# 02 PROTO-SCALE™

## Wheel Set Kits

### ADDENDUM

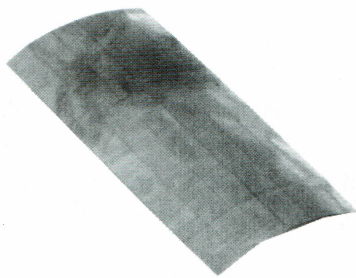
If you find loose fitting conductive axle bushings in the truck block or you find the model hesitates during operation, install shims to the conductive axle bushing to improve the conductivity and operation.

The kit comes with 0.1 mm and 0.03 mm thick shims as pictured below. In general one 0.1 mm shim per conductive axle bushing should resolve most conductivity problems. However, the 0.03 mm thick shims are included should you need more or less than one 0.1 mm thick shim. Each shim is easily removed from the holding rack with a slight twist.
